COORDINATED POWER ENGINEERING, INC.

FOR RECORD Revised for Alt HEQ1 and 2- ECB's

Study Type: Revised Short-Circuit, Coordination & Arc Flash Hazard Study

CPE Report No.: 21870

3.5.3 COORDINATION CURVE SHEET No. 3

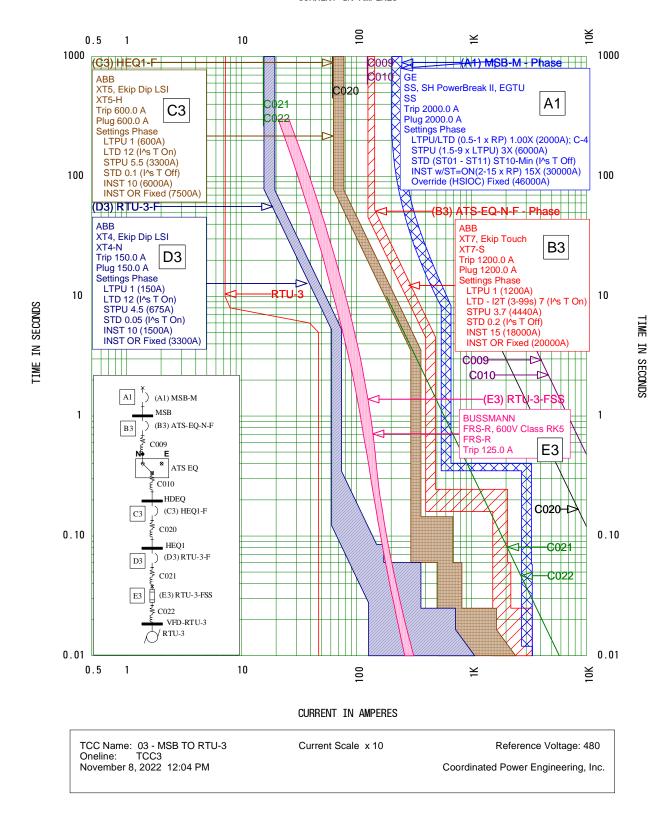
- Panel HEQ1 remains rated 25kA at 480V.
- Feeder breakers to RTU-3 and RTU-4 are revised to ABB XT4-N (Ekip Dip LSI Trip Unit) rated 25kA at 480V. Curve Sheet #3 (Page 3-16) and the Settings Table (Page 5-4) are revised accordingly.
